Intel® 82371AB PIIX4, Intel® 82371EB PIIX4E, Intel® 82371MB PIIX4M

Specification Update

January 2002

Document Number: 297738-017

TD CONTROL AND STATUS (DWORD 1: 04-07h)

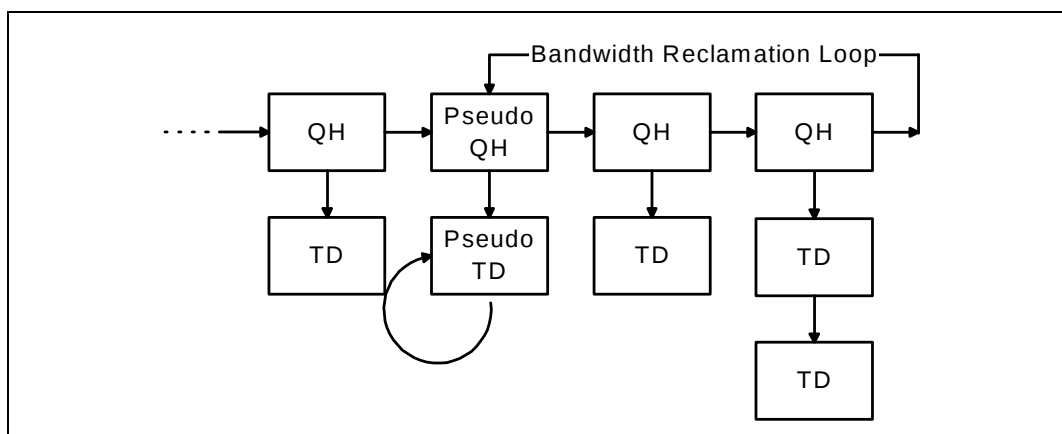
The Active status bit (bit 23) must be left unset at 0 indicating that the PIIX4/PIIX4E/PIIX4M should not execute this TD.

QUEUE HEAD LINK POINTER (DWORD 0: 00-03h)

The Queue Head Link Pointer (QHLP=bits [31:4]) must be set to point to the pseudo TD.
